i960[®] VH Embedded-PCI Processor

Specification Update

August 2004

Order Number: **273174-011**

Figure 1. DRAM RAS# Configurations

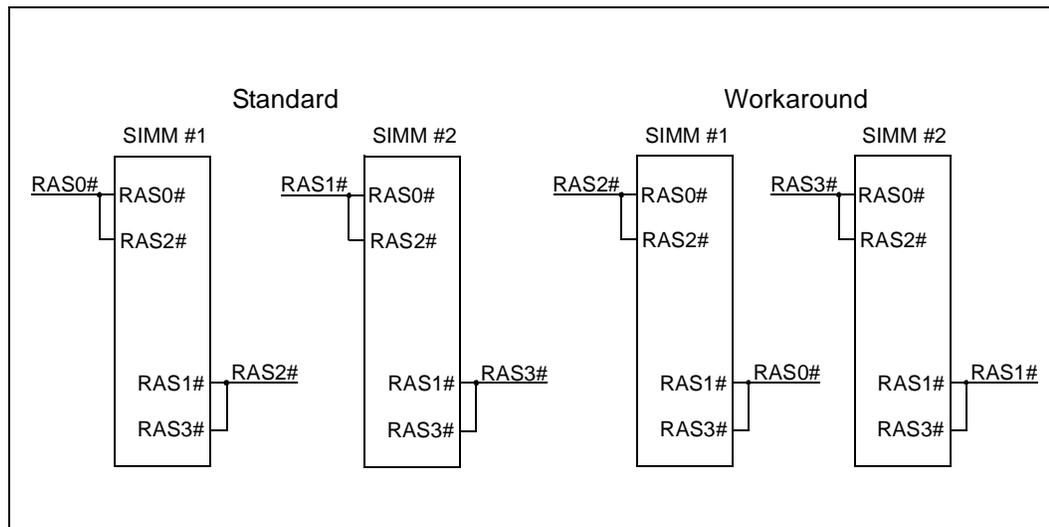
Workaround: Two workarounds are presented. The *CASE 1 WORKAROUND* describes a software modification. The *CASE 2 WORKAROUND* describes a hardware modification.

In a standard DRAM configuration, RAS0# and RAS1# are routed to the front sides of the SIMMs, and RAS2# and RAS3# are routed to the back sides of the SIMMs. To implement this workaround, swap RAS0# and RAS2# and swap RAS1# and RAS3#. This routes RAS2# and RAS3# to the front sides of their respective SIMMs, and routes RAS0# and RAS1# to the back sides of their respective SIMMs (See [Figure 1](#)). To determine which RAS# is asserted for a particular address and DRAM configuration, see [Table 1](#).

In an application using 4 Mbytes per bank/leaf and two single-sided SIMMs populated in a four bank design (total DRAM = 8 Mbytes), the following registers are set:

DRAM Bank Control Register (DBCR) = 0x0000 0013
 DRAM Base Address Register (DBAR) = 0xFE80 0000

The DBCR and DBAR values imply an address range of 8 Mbytes from 0xFE80 0000 to 0xFEFF FFFF.

When initializing from 80960VH DRAM, the first instruction fetch of the IBR is hard-coded to address 0xFEFF FF30; as a result, A23:22 = 11₂ and RAS3# is asserted. With the workaround in place, the RAS# lines are swapped and RAS3# is connected to the front side of the second SIMM and the IBR can be read.
